SUBJECT: Post-Closure of the Fort Bragg - Longstreet Road MSW Landfill Unit.  
**FACILITY PERMIT #: 26-02**  
**Modification #1: Construction of temporary concrete batch plant.**

FACILITY PERMIT NO: 26-02  
Closure of MSWLF Unit  
Date: 21 MAY 2001  
MODIFICATION #1 DATED: 03/19/02

**LETTER OF CLOSURE**

- B. The request to place a temporary concrete batch plant at the site is approved in accordance with the letter dated 12 March 2002 from Roderick Chisholm for Colonel Gregory G. Bean and the site drawing provided with said letter. The following conditions will apply:

FIGURE 2. PROPOSED SANITARY LANDFILL SITE 2 FORT BRAGG, N.C.

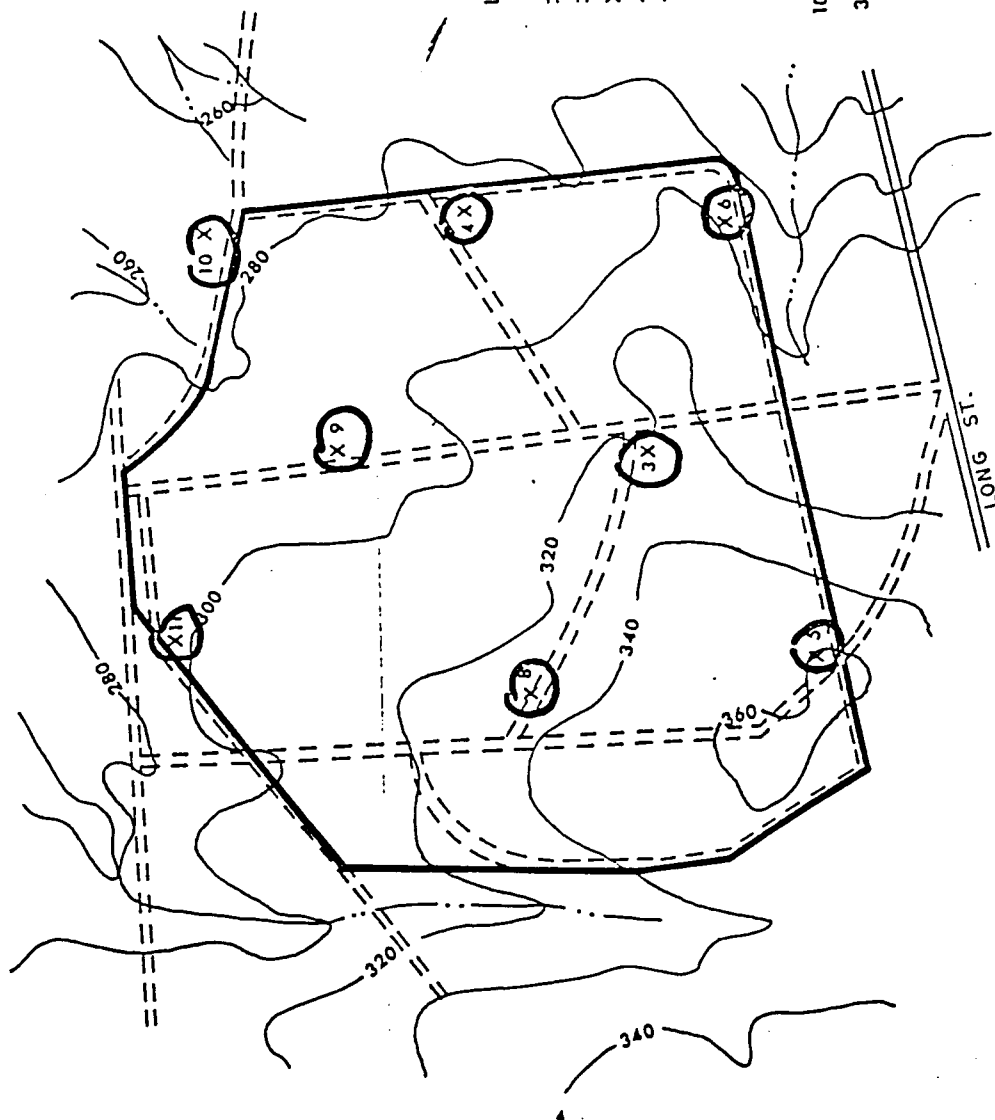
- i. All structures, stockpiles of materials and portland cement containers/trailers shall be a minimum of 150' from any monitoring well at the site, specifically MW-11 as shown on the attached site drawing dated 26 & 27 September 2001;

- ii. The site of the temporary batch plant shall be within the indicated 300'x300' area as shown on the plan;
  - iii. Truck washout shall be kept to a minimum. If excessive runoff occurs from washout, berming of a discrete area shall be done. This bermed area shall be cleaned of excess concrete/portland cement slurry once hardened and disposed of at the Fort Bragg C&D landfill;
